Question Count and Status

Project Management

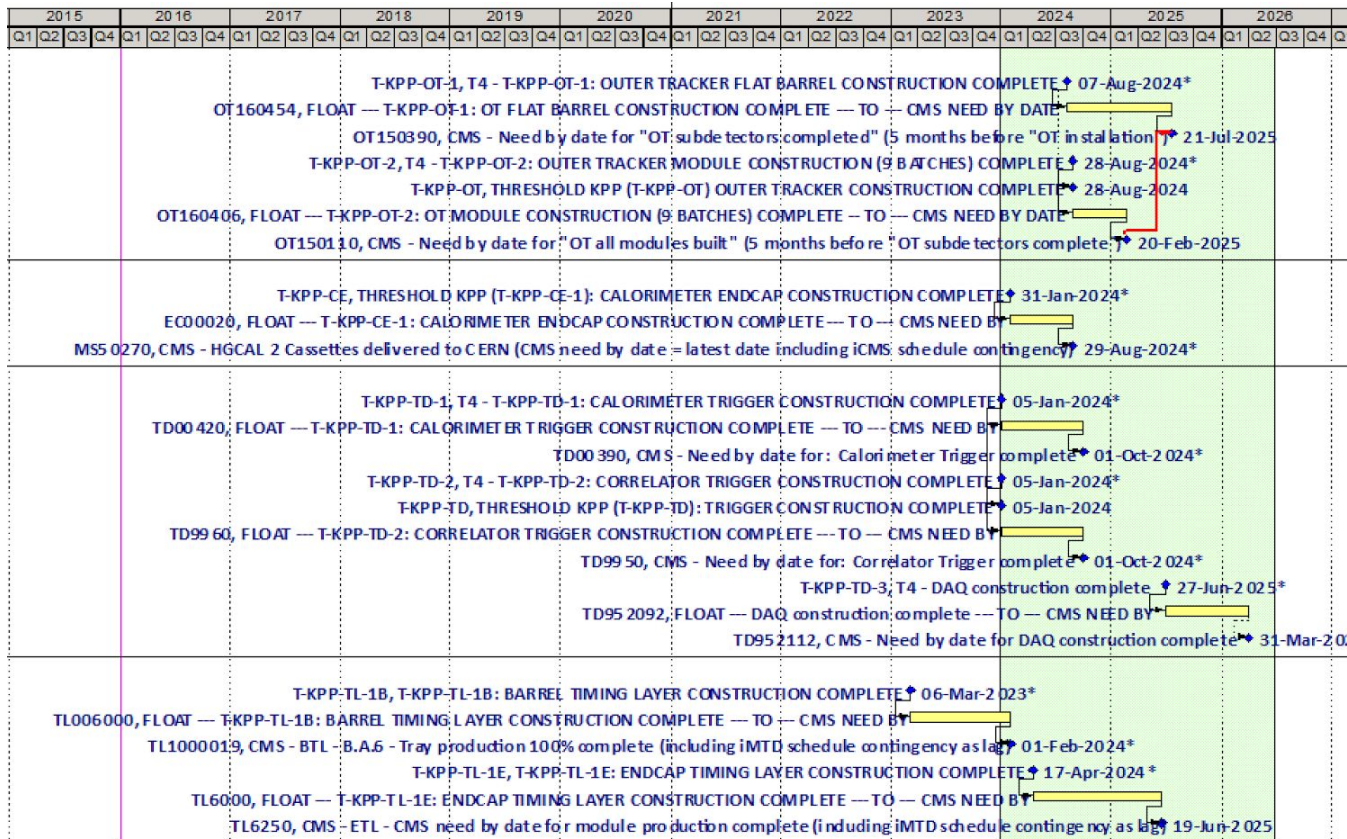
1. Critical Path scheduled from P6 by L2 showing Total Float.

The L2 areas in P6 are completely independent without logic links between them. The project has a critical path for each L2 area as shown in the plenary presentations. The meaningful critical paths for each L2 area terminate on the delivery of the threshold KPP scope (with well-defined deliverables). The objective KPP scope includes integration and commissioning tasks, which, by their very nature, will make use of all time available before the installation of the detectors into CMS.

To determine the critical paths, we constrain each threshold KPP milestone to its technical finish date so that total floats for each L2 area are calculated with respect to the completion of the threshold KPP. Hence the project critical path comprises all activities with Total float = 0d.

The resulting Gantt chart, with columns showing Total Float and Base Cost (i.e. Planned Cost) is here: <https://cms-docdb.cern.ch/cgi-bin/DocDB/RetrieveFile?docid=13245&filename=2019-10-22---HL-LHC-CMS-Upgrades---Gantt-Chart---with-Total-Float-and-Cost.pdf&version=30>

Notes on changes to P6 since the frozen versions that were used to generate review documents:

- (1) A trivial bug was fixed in 402.4 CE. This related to a constrained milestone logic and lag that resulted in spurious negative float appearing for some activities in 402.4 CE. This bug did not affect any costs or dates.
- (2) An unrelated minor schedule fix that was made after the cost documents were frozen for the review advanced two activities in Calorimeter Endcap, resulting in a slight change in cost (reduction of \$6k due to less escalation) in the latest P6 files compared to the frozen cost book.
